# Access Compliance Report

## Public Rights-of-Way

### (Curb Ramps)

Intersection ID: 16578	Main Street: CONWAY_AV	Cross Street: SCALEYBARK_RD	Location: W
ADA ID: 4AC11D4FE51A	Ramp Type: Directional1	Initial Pass/Fail: Fail	Overall Compliance: No
Severity Score: 12.5			
Codes/Mitigation Info/Possible Solution		Field Measurements/Component Compliance

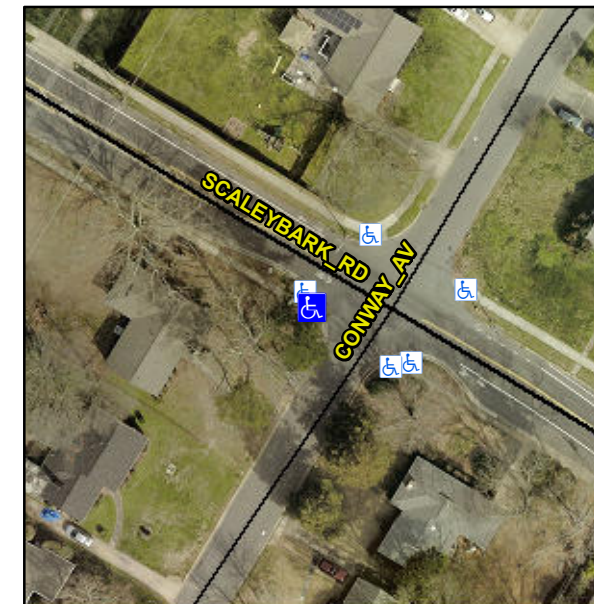
**R304.5.3**

**Remove & Replace Entire Ramp.**
